SUBJECT: NuScale Power, LLC Supplemental Response to NRC Request for Additional Information No. 151 (eRAI No. 8974) on the NuScale Design Certification Application

NuScale Supplemental Response to NRC Request for Additional Information eRAI No. 8974

NRC Question No.: 03.08.04-23

Figure 3.7.2-164: In-Structure Response Spectra at the Reactor Flange Tool Base, Node 6328, due to X, Y, and Z Inputs of Capitola Excitation for Soil Type 7, Uncracked Condition

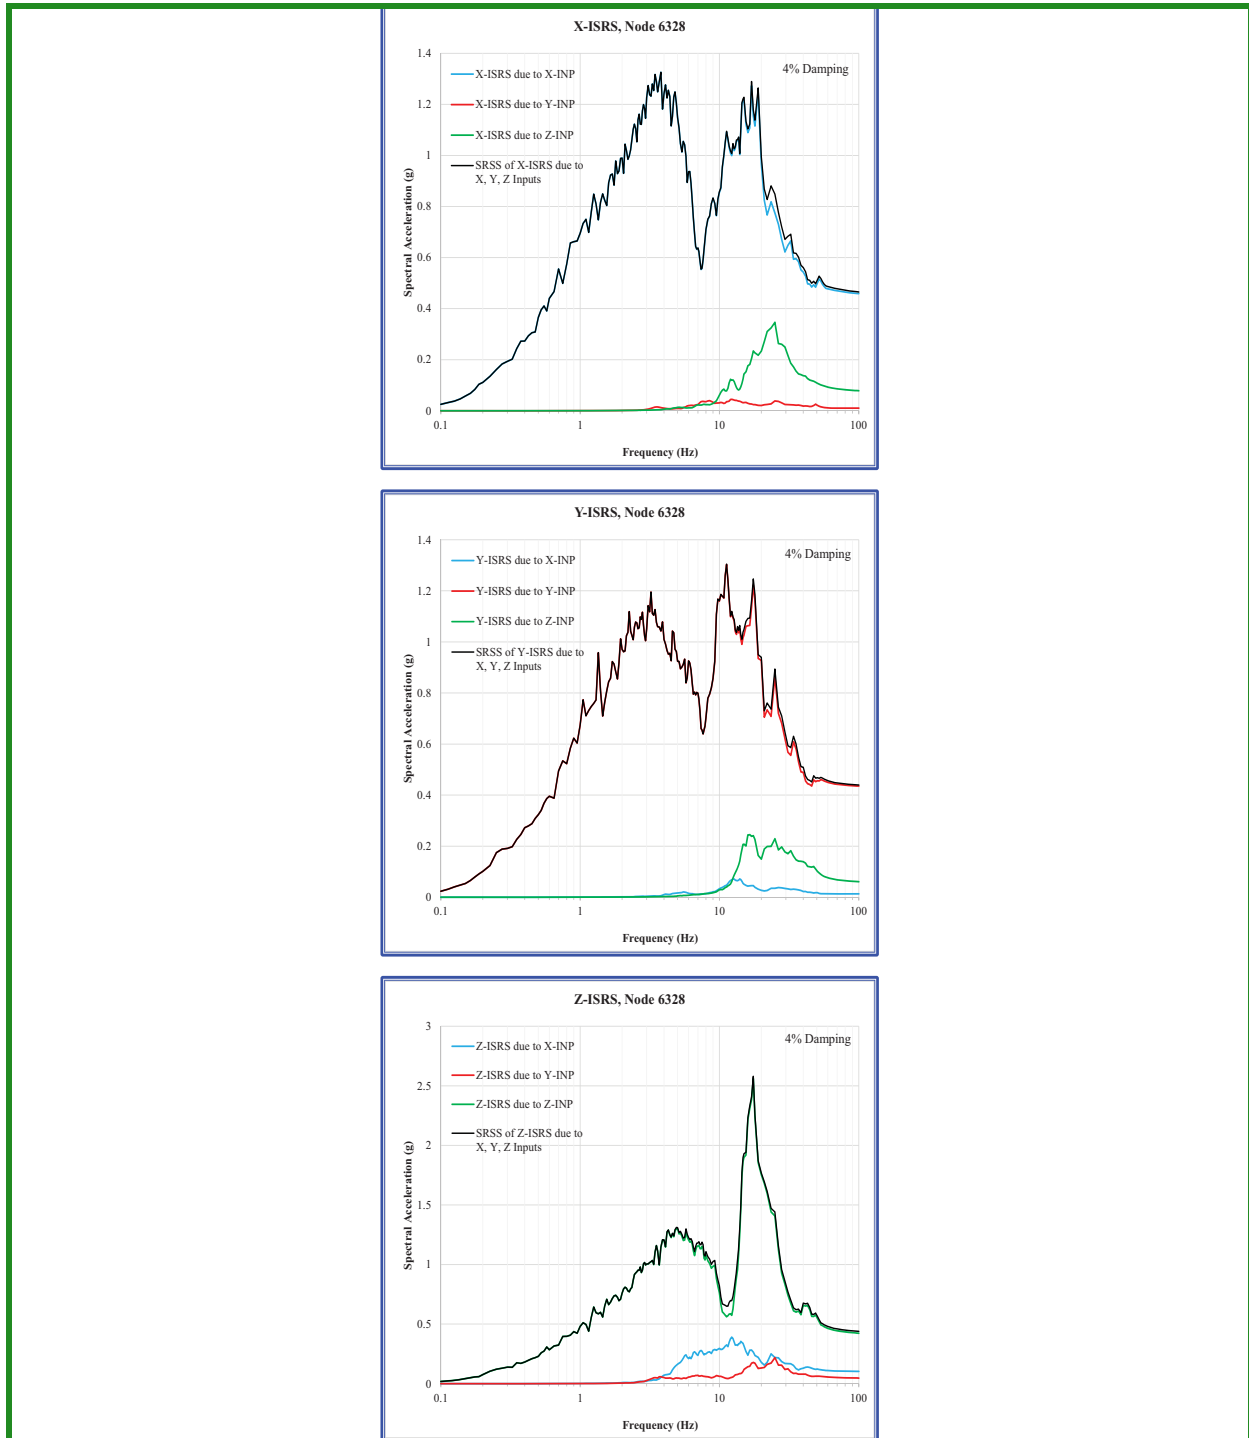
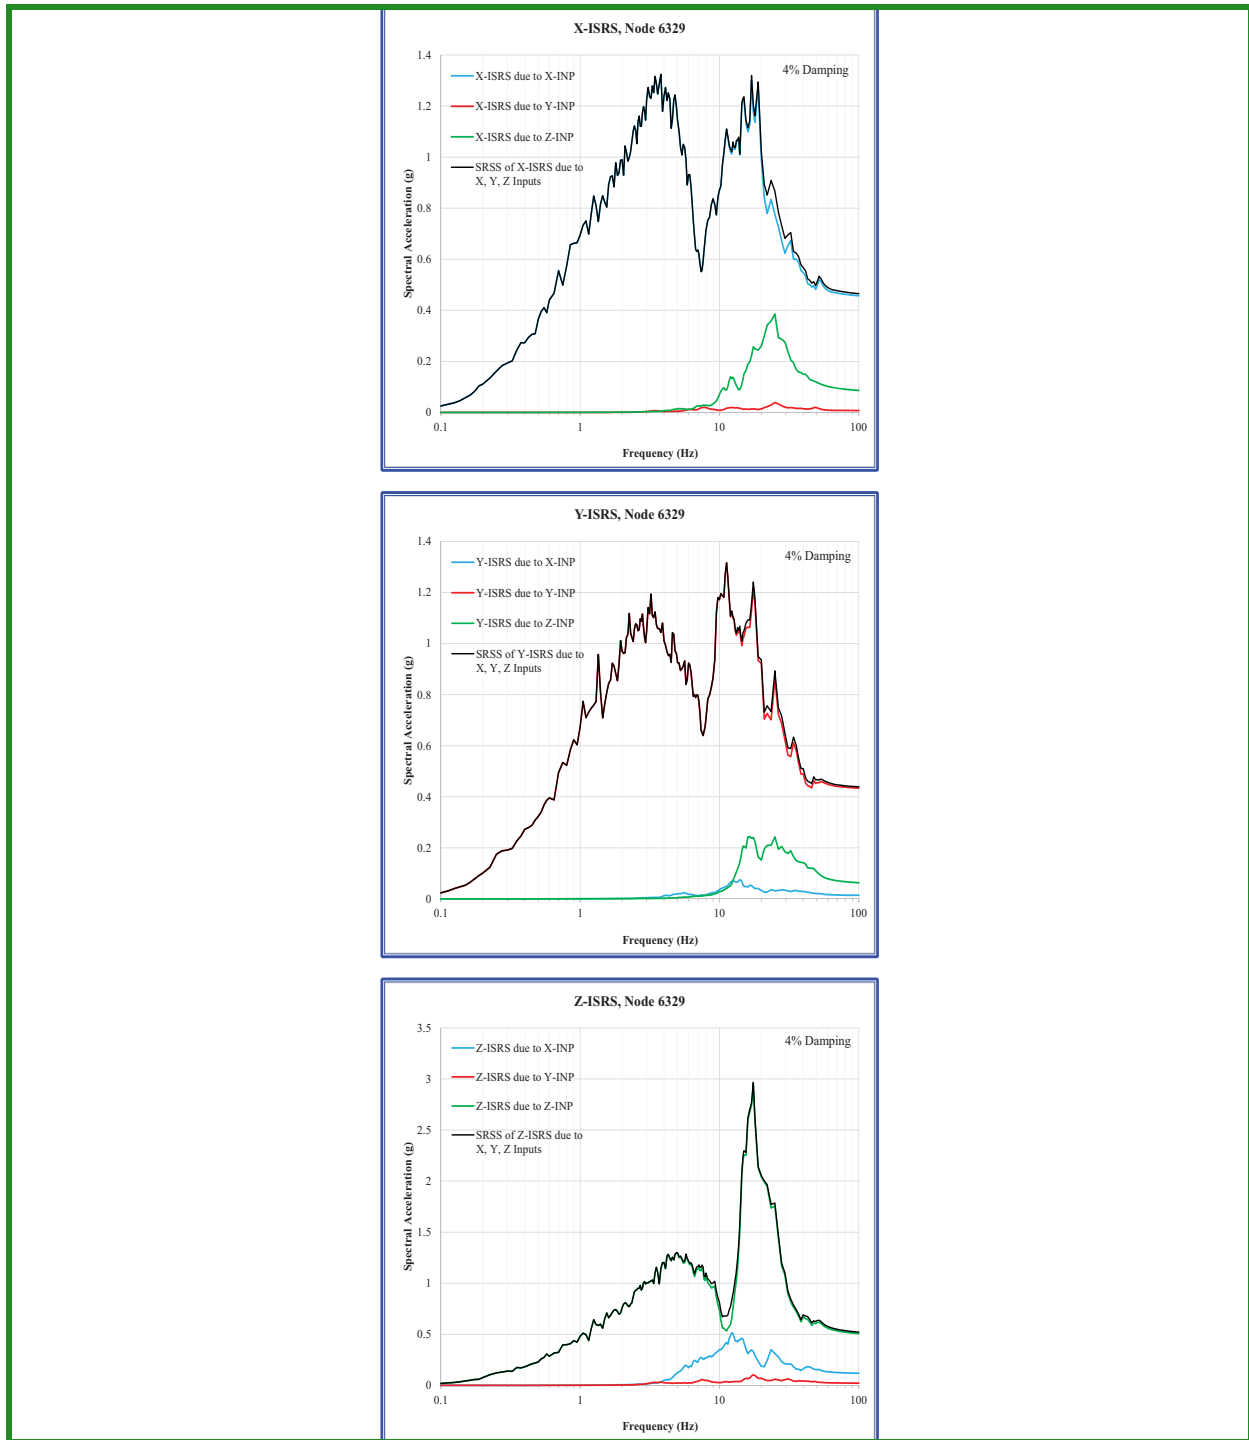
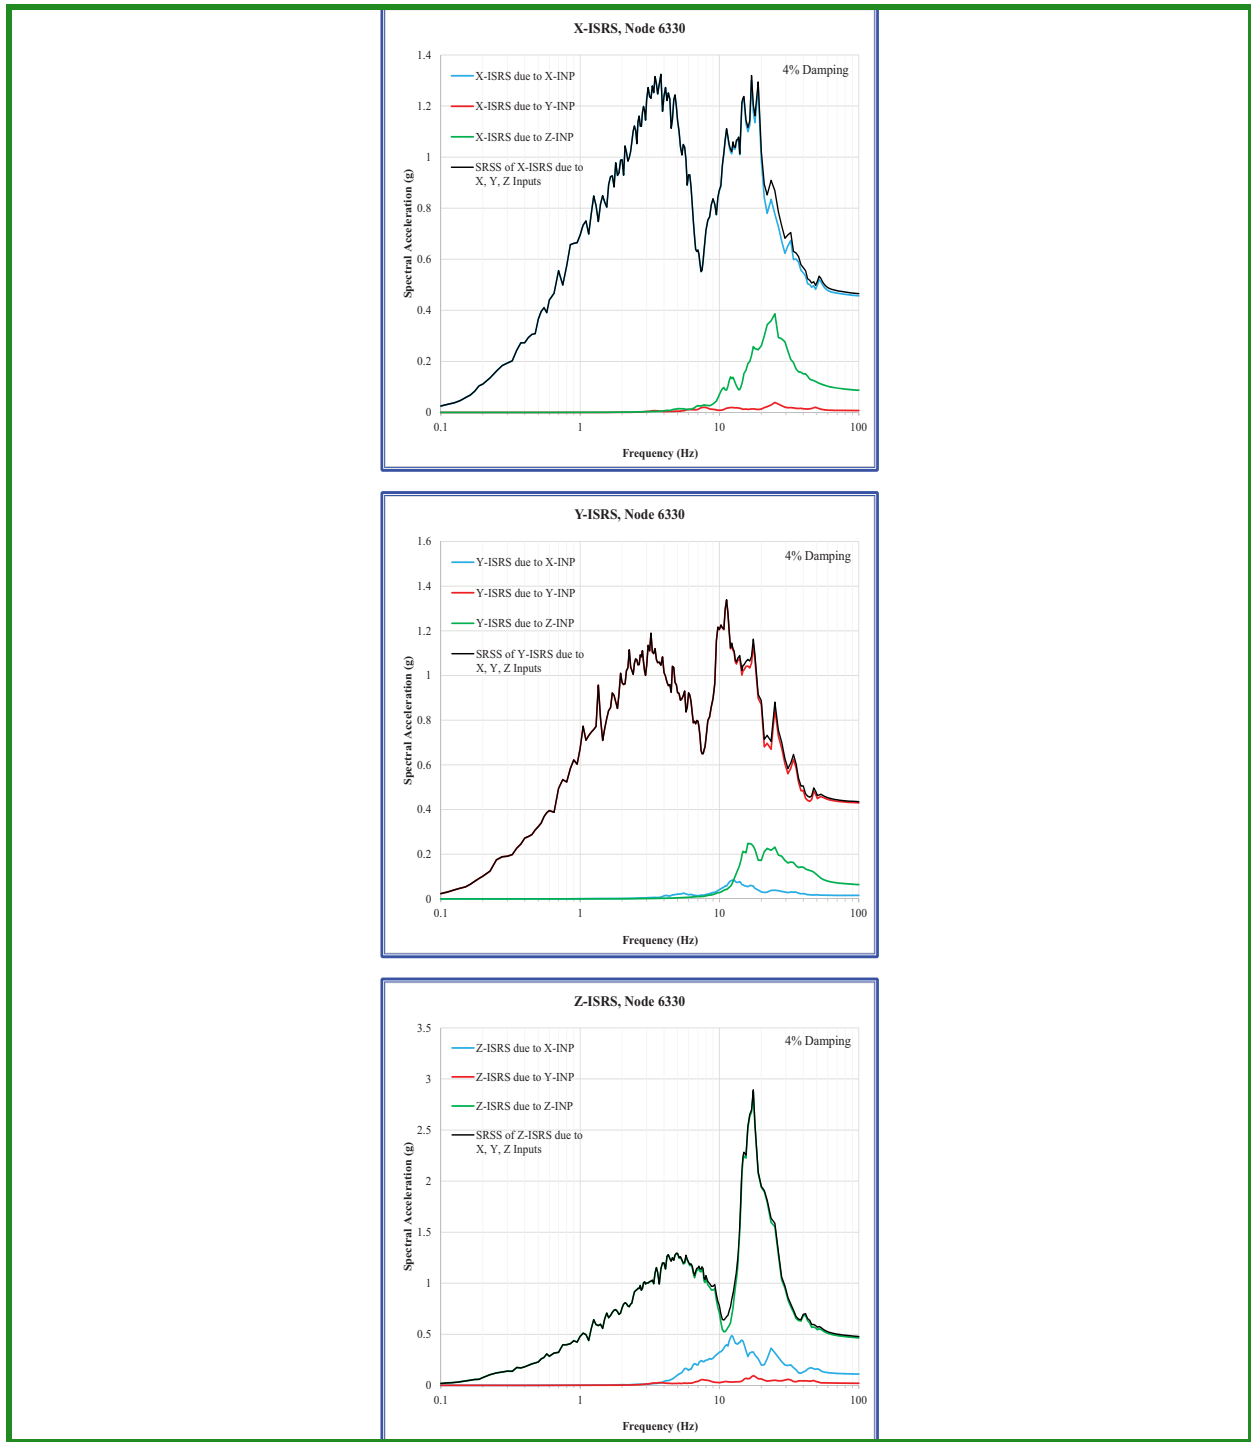
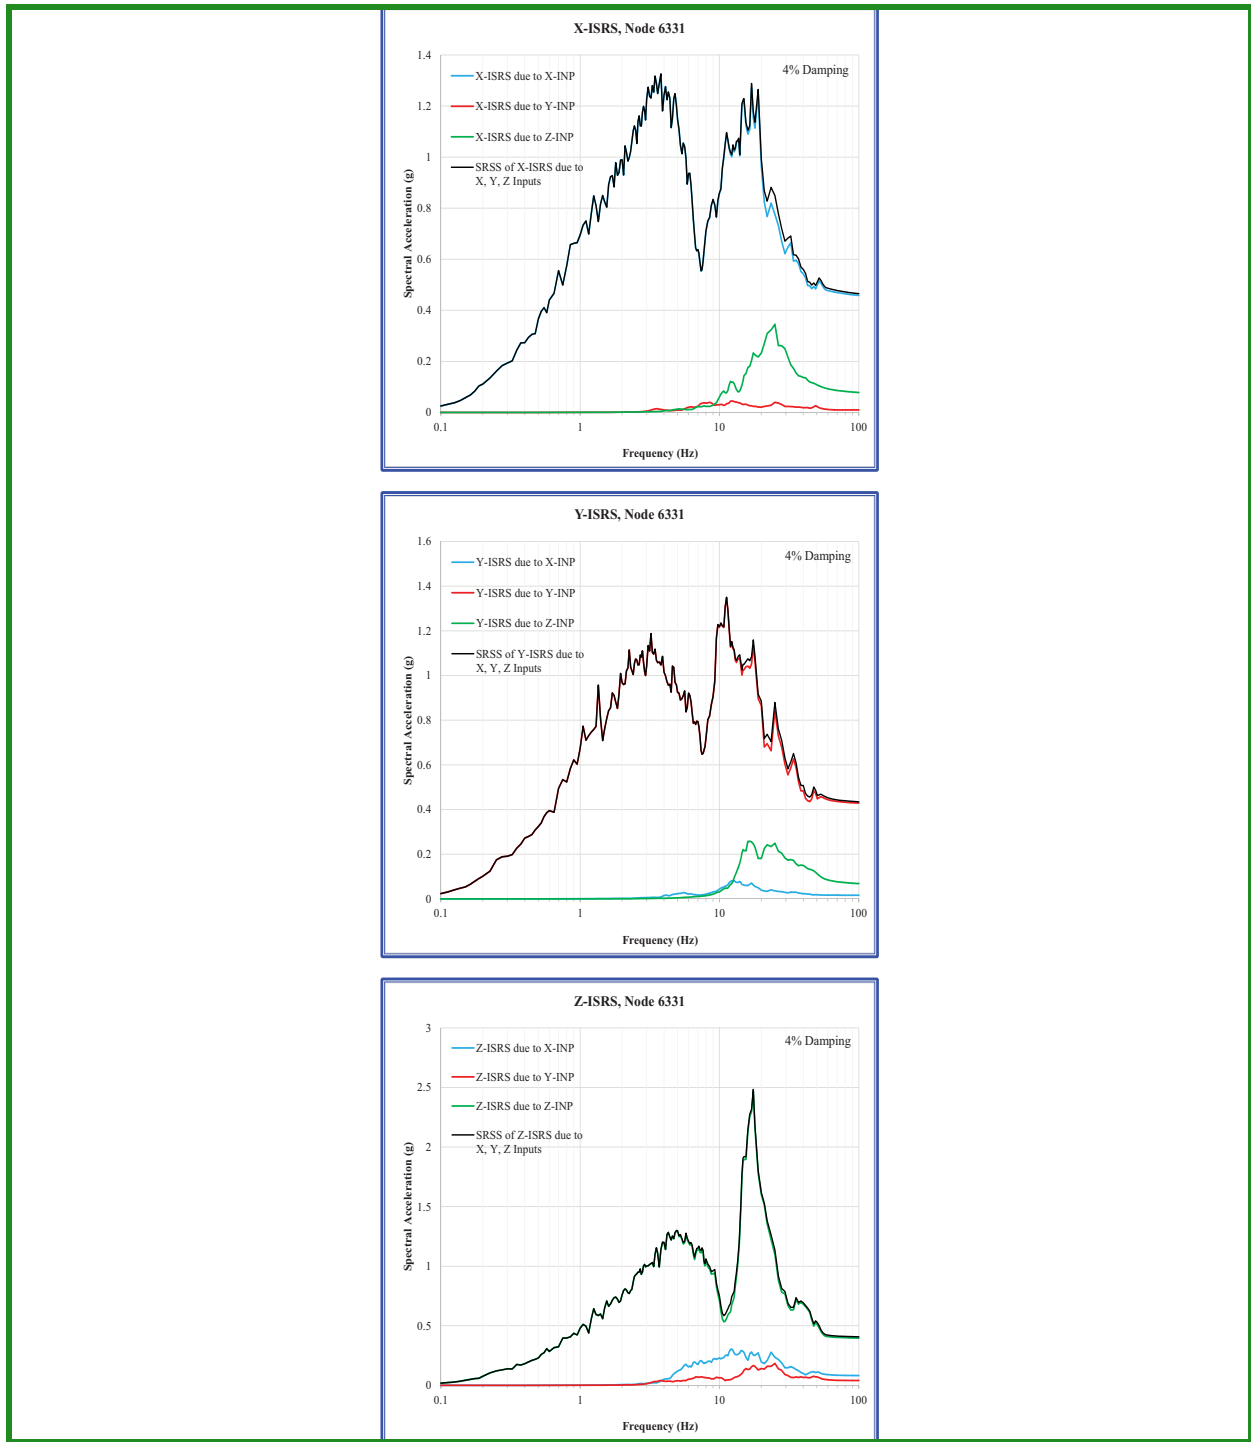
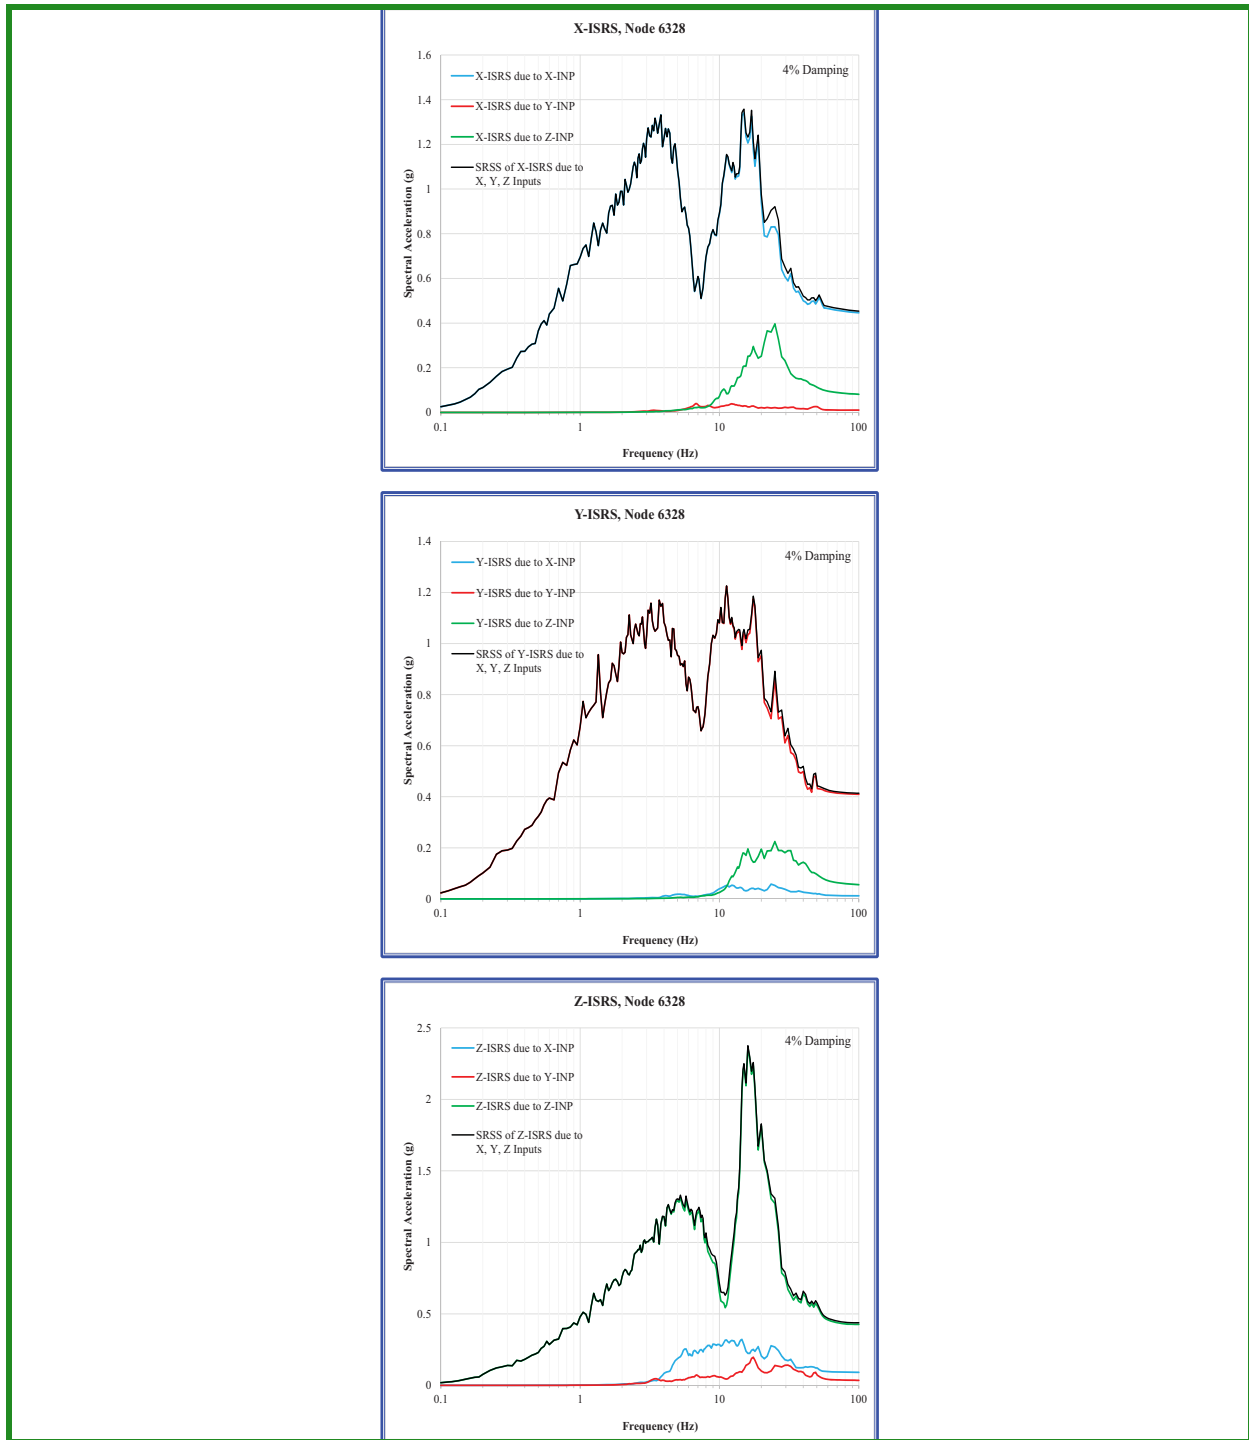
Consistent with the description for COL item 3.8-2, please include the ISRS for the skirt supports, lug restraints, and RFT base in the ISRS list for the RXB (i.e. the ISRS list related to COL item 3.8-2). Also, please include the ISRS for the bioshield.

FSAR Tier 2, Section 3.8.4.8 has been revised to include, within the list of RXB design parameters/results, the ISRS at the skirt supports, lug restraints, RFT base and the bioshields.

- FIRS Compare to Figure 3.7.1-1 through Figure 3.7.1-4
- ISRS at the reactor pool floor Compare to Figure 3.7.2-108
- ~~ISRS at the NPM lug restraints~~ ~~Compare to Figure 3.7.2-116~~
- ISRS at the RBC wheels Compare to Figure 3.7.2-114
- ISRS at grade Compare to Figure 3.7.2-111
- ISRS at the roof Compare to Figure 3.7.2-113
- ISRS at the NPM skirt supports Compare to Figure 3.7.2-156 and Figure 3.7.2-157
- ISRS at the NPM lug restraints Compare to Figure 3.7.2-158 through Figure 3.7.2-163
- ISRS at the RFT base Compare to Figure 3.7.2-164 through Figure 3.7.2-171
- ISRS at the bioshields Compare to Figure 3.7.3-4a through Figure 3.7.3-4c
